1	PBY-5	28F6837	1
	MODEL	NEXT ASSY.

NAME ASSEMBLY-FURN.-Y HOT AIR DUCT-SINGLE HEATER

CONSOLIDATED AIRCRAFT CORP. SAN DIEGO, CALIF.

J 28F6815

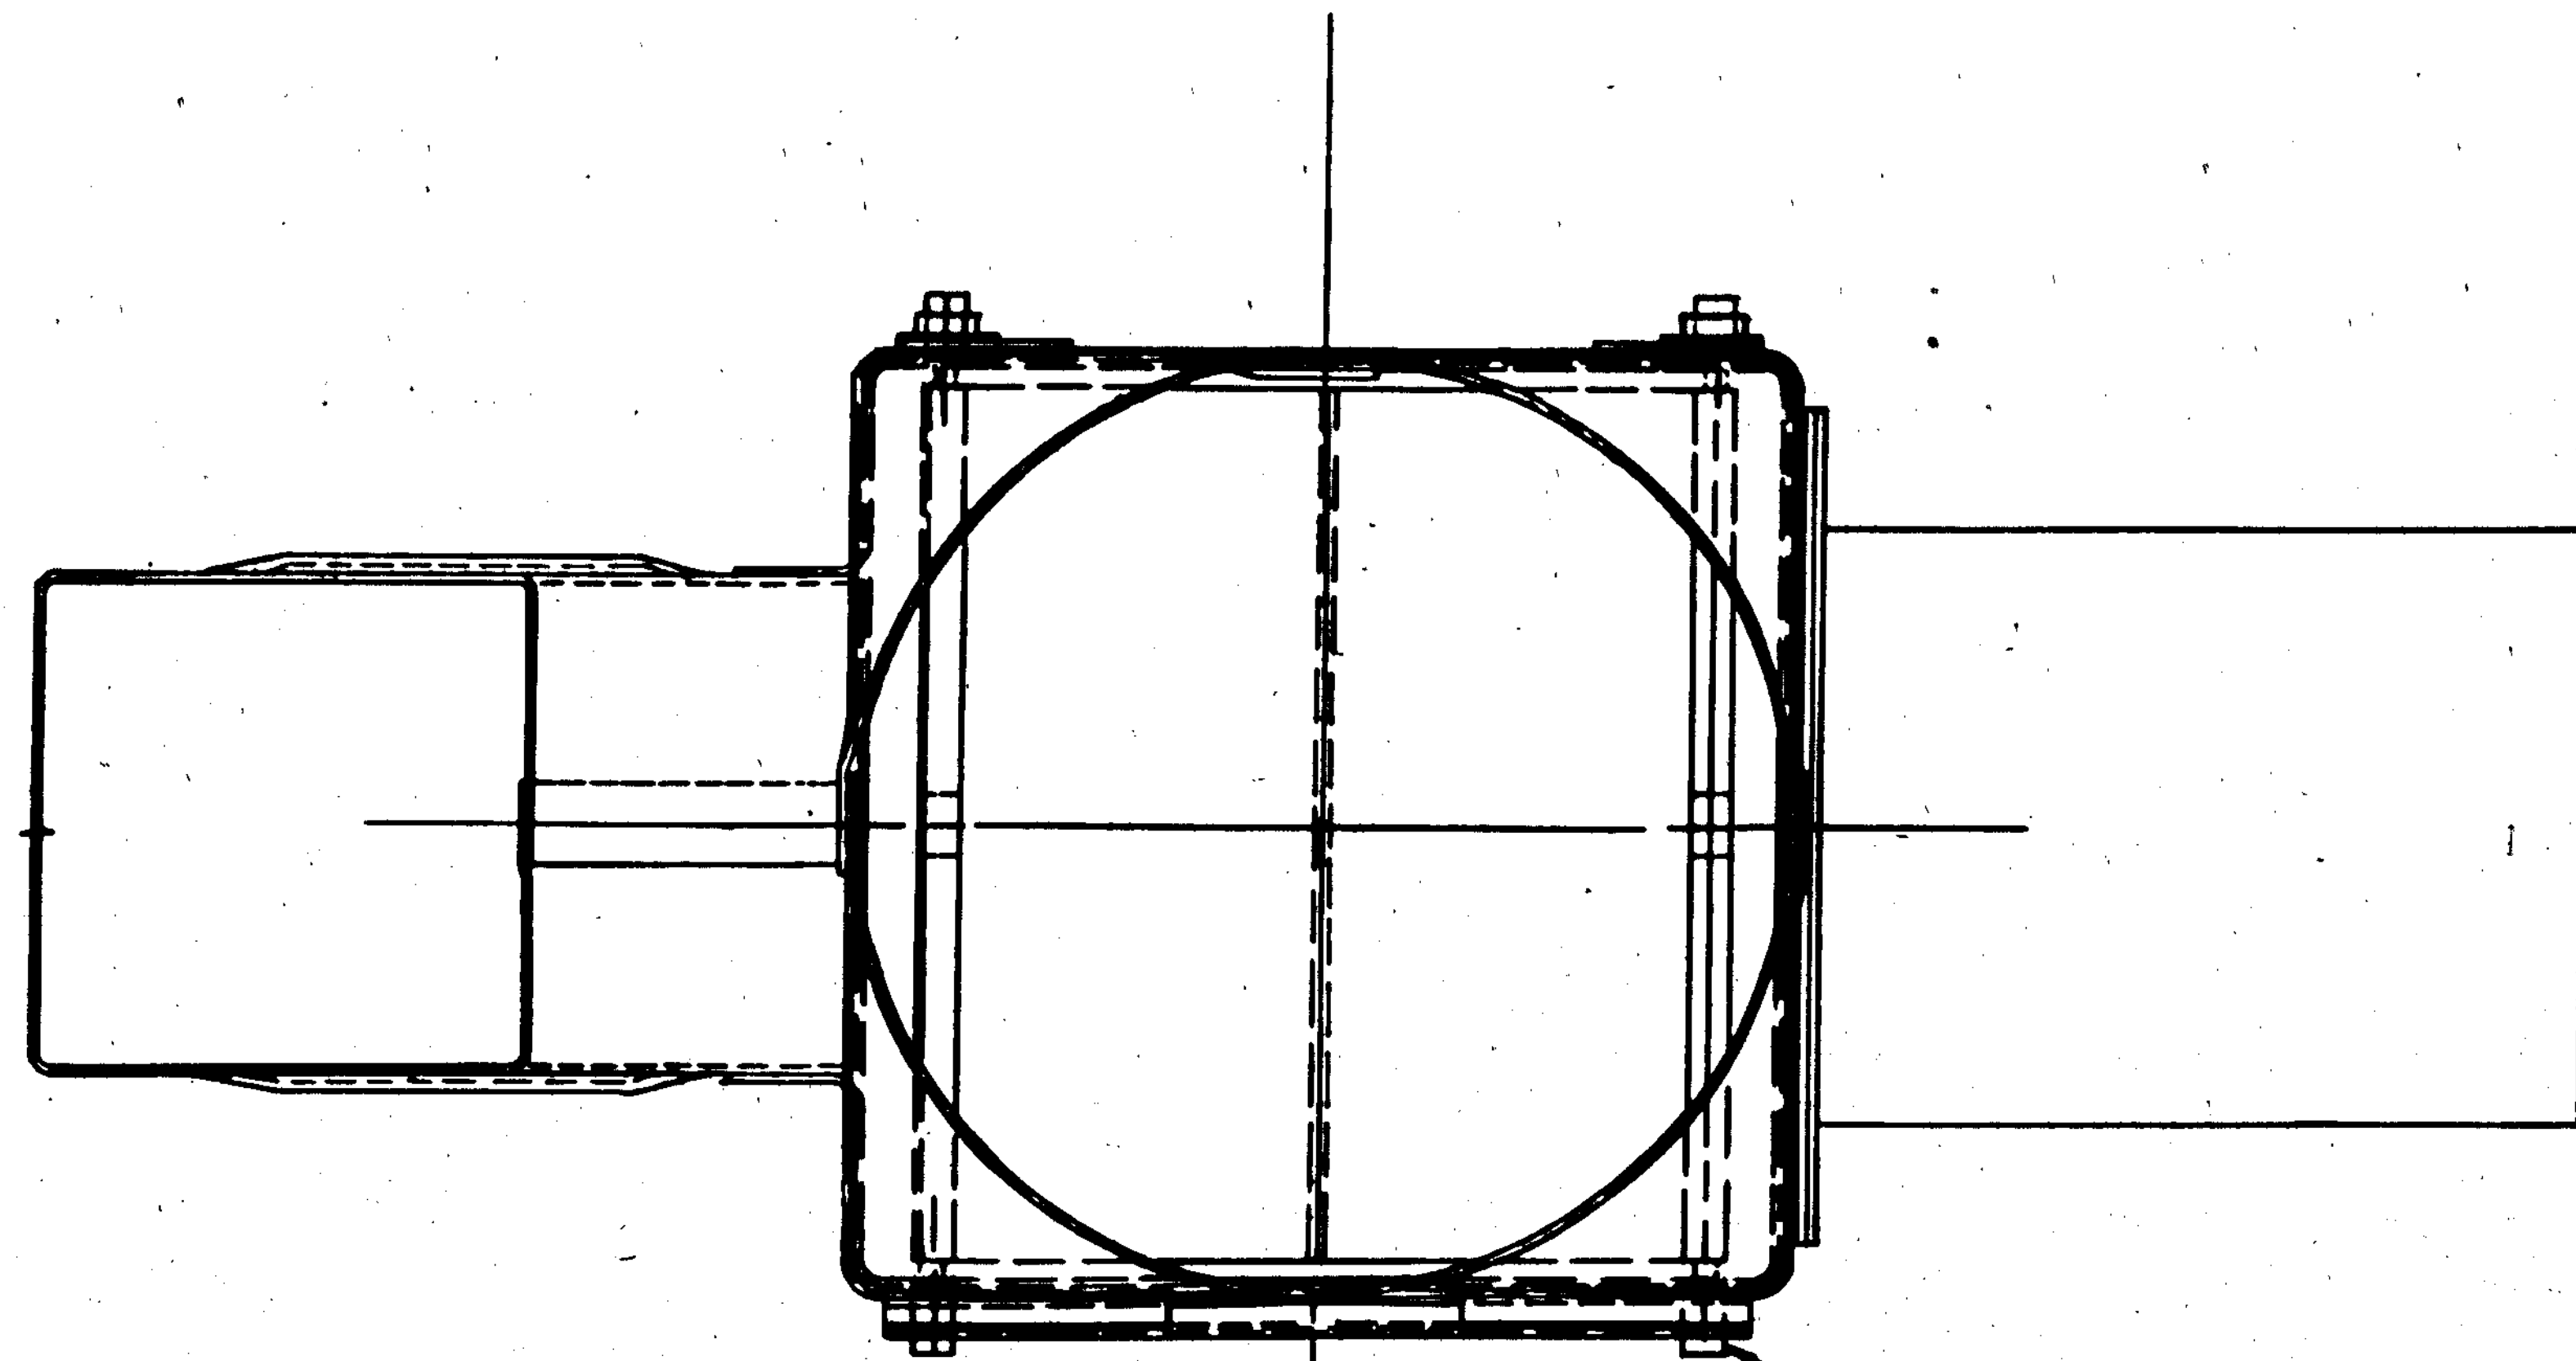
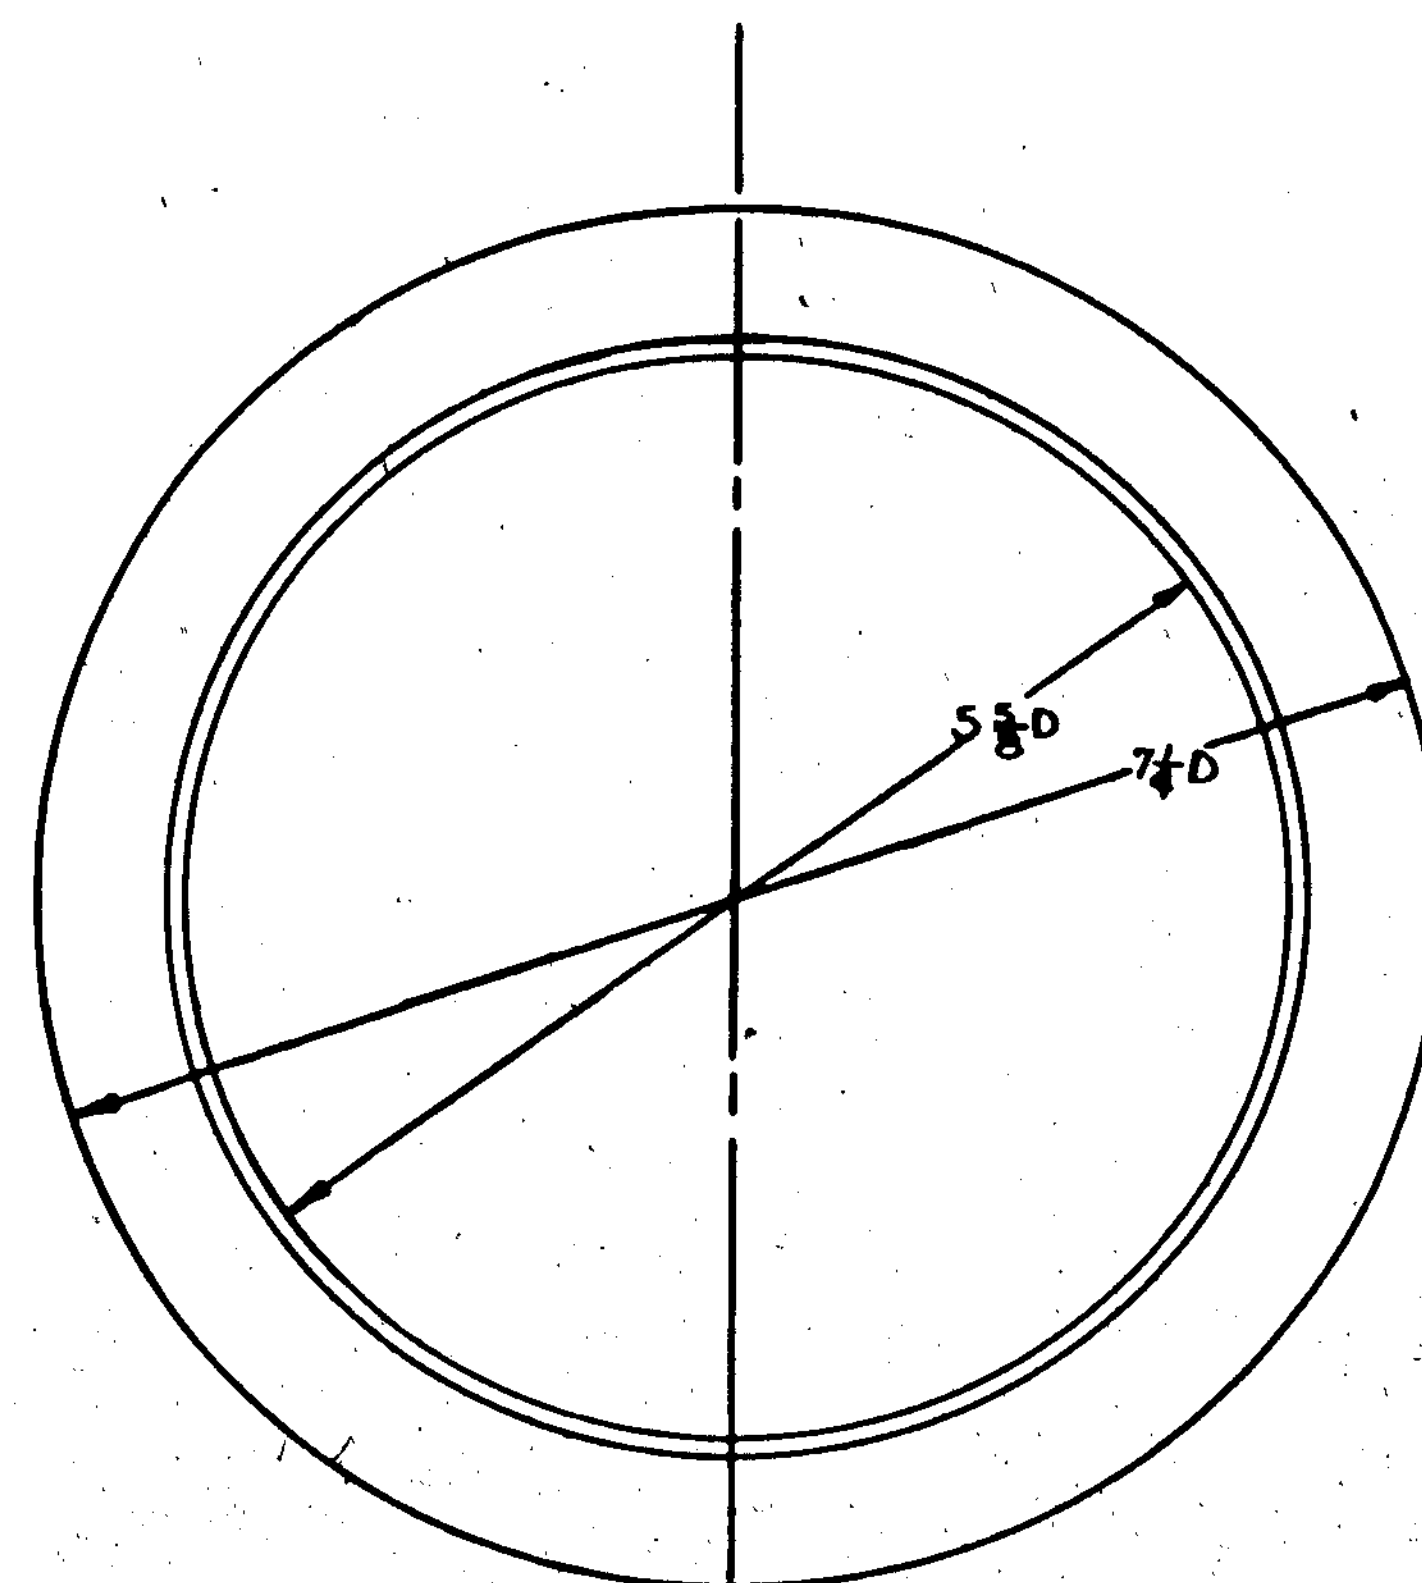
LTR	ALTERATION	DATE	BY
A	CHANGED REQ. OF AN380-C2-3 ... [illegible]		
	RIVETS ADDED AN526-1032-16 (2)		
	AC372-1032 (2) Q7102-AL10 (4)		
	WT. CHANGE NEG.	[illegible]	
B	DIM. 1/8 WAS ... [illegible]		
	... -7 WAS -6. WT. CHG. NEG.	[illegible]	
C	DIM. 7 1/8 WAS ... WT. CHG. NEG.	[illegible]	
D	AN3-04A BOLT ... WAS AN526-...		
	... SCREW. WT. CHG. NEG.	[illegible]
